CORPORATION OF HARPERS FERRY

Interface Utility Coordination w/Fire Marshal

Meeting Minutes

HILL TOP HOUSE HOTEL

Site/Ground Level Plan

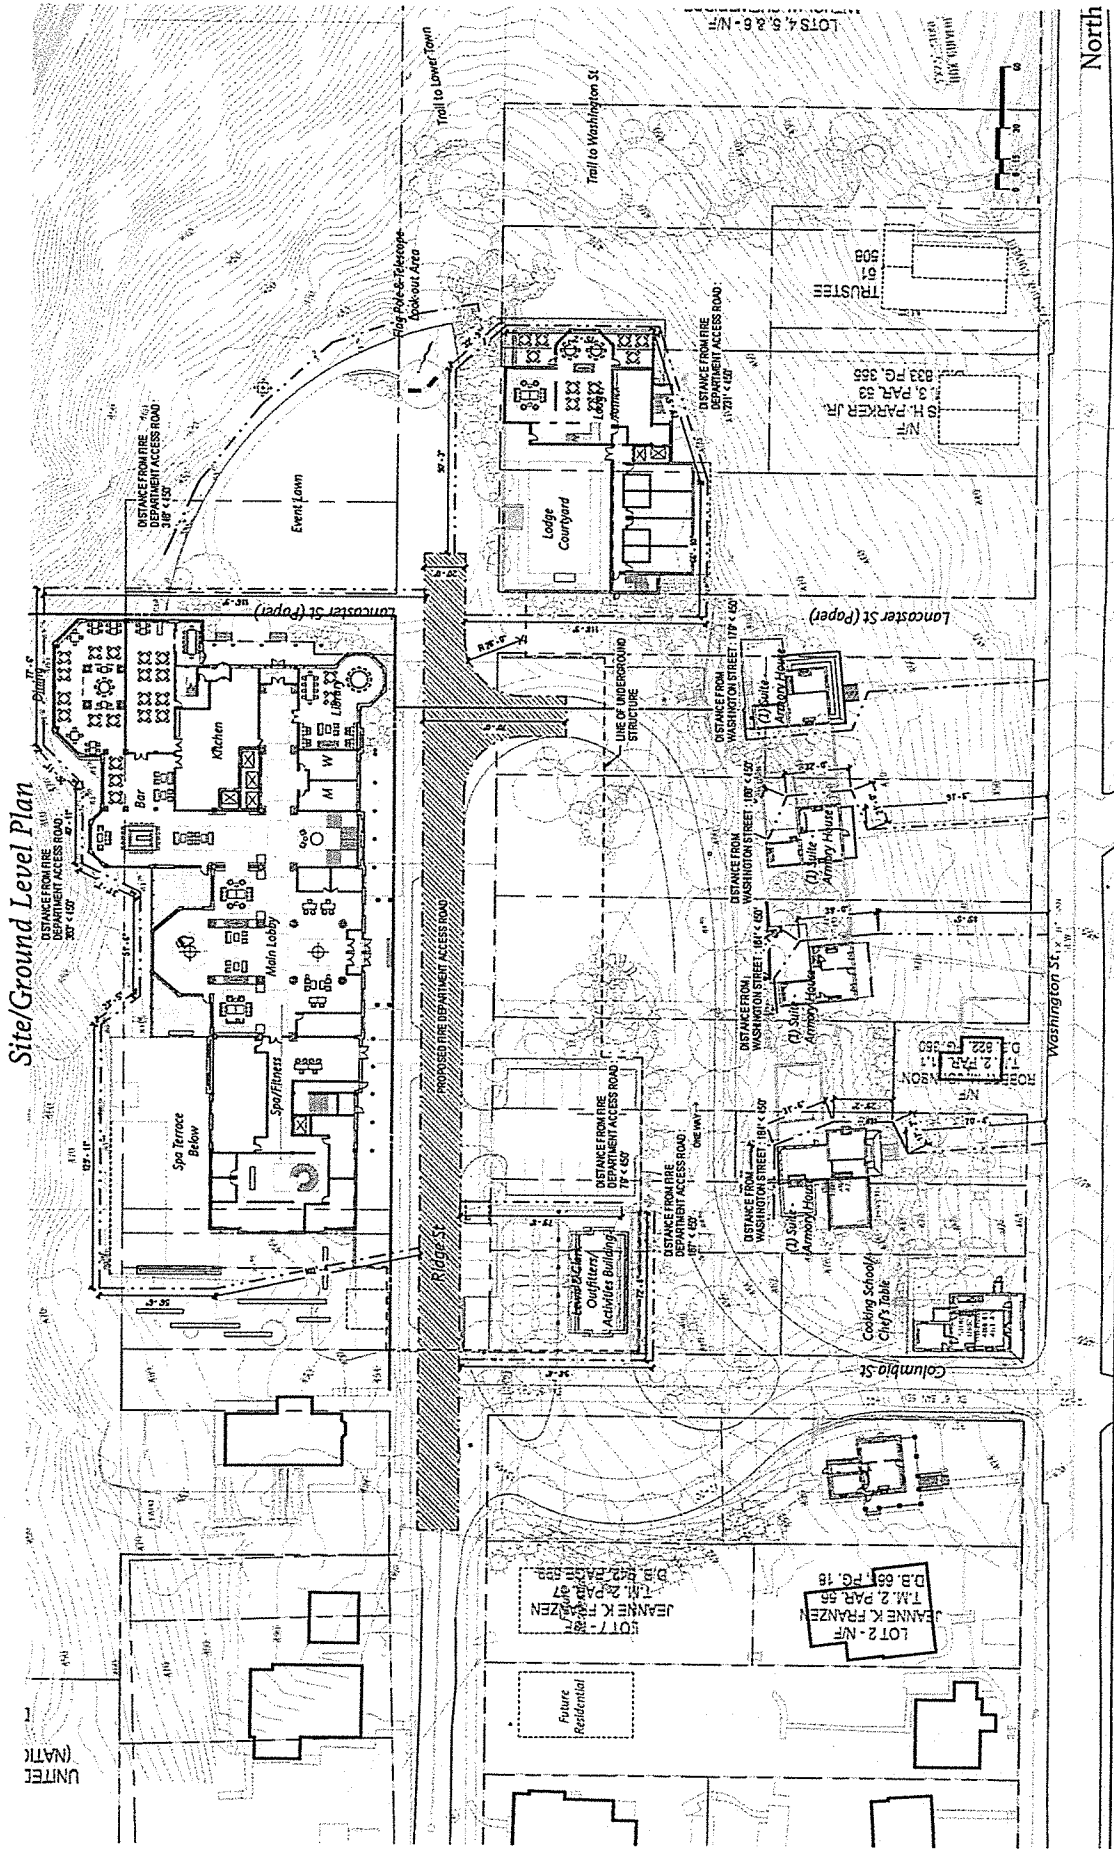
Laurel Ziemianski provided a copy of the Hill Top House Hotel's Site/Ground Level Emergency Vehicle Access Plan with red hatching denoting primary firetruck access in red with a red dashed line showing firehose distance from Fire Department access road to all sides of building (plan dated 8/21/18). A black line donates 75' between hydrant and the area they are protecting.

Fire trucks need a 34-foot turning radius. There are no plans in the Town Hall to widen the streets. Per WV Code, the road must be 20 feet. Code NFPA1 Chapter 18.2.3.4.1.1. Jessie Berg stated developer will be modifying Columbia and Washington Streets corner access. SWaN indicated Columbia Street and E Ridge Street will be 24 feet wide to accommodate 2-way traffic. Fire Marshal John Holben stated these are guidelines however in Harpers Ferry we could most likely get waivers due to topography.

John Holben stated (1) WVSFM would need direct access via an outside entrance to the sprinkler room, (2) Need fire hydrant hook up on E Ridge Street hotel side of the building towards Columbia Street intersection (they may use existing hydrant), (3) need to add a new

hydrant near the Lodge on east end of E Ridge St. Nevin Kilmer confirmed a hydrant needs to be 75' from building.

This firefighting plan (attached) states primary access route from firehouse to Hill Top is east on Washington Street to left on Jackson St. (which is relatively flat) to right on E Ridge St. and onward to hotel. John Holben, Jefferson County Fire Marshal stated this is the historical route taken by emergency vehicles and this proposed approach is an acceptable access plan. It was noted that a fire truck can make a 3-point turn on E Ridge Street backing onto the arrival road near the Lodge to turnaround. John also stated this common 3-point turn is acceptable for the plan and fire department access road over underground structure is good. However, it was stated that no parking will be allowed anywhere on E Ridge in front of hotel structure. Hotel and Lodge will have full sprinkler system.

The arrival road behind the Armory houses is showing 20' on the current plan but SWAN prefers to minimize that to 15'. At the site visit following the meeting, John Holben stated that armory house fires would be fought from the arrival road and not from Washington Street. He also approved the width of the arrival road to be 15' by Authorization has Jurisdiction (AHJ). Only the primary firefighting access road needs to meet the code requirements. The final design of arrival road will have a 15' width of pavement, a grass strip next to pavement, then a sidewalk. This is his approved layout. Armory Houses will have sprinkler systems.

Regarding the height of the hotel, Nevin Kilmer (Berkley county Fire Marshal, John's backup) stated from ground level to the ceiling of the highest hotel room need to be at a maximum of 40'. If it's more, this will be considered a high-rise. Yoonho Lee: Assuming 9'-0" ceiling at Level 04 and 10'-high truck, the dimension is 37'-5" < 40'-0". Need pressurized stairwells/fans for smoke evacuation. Yoonho Lee noted that the total height of the structure is under 55'.
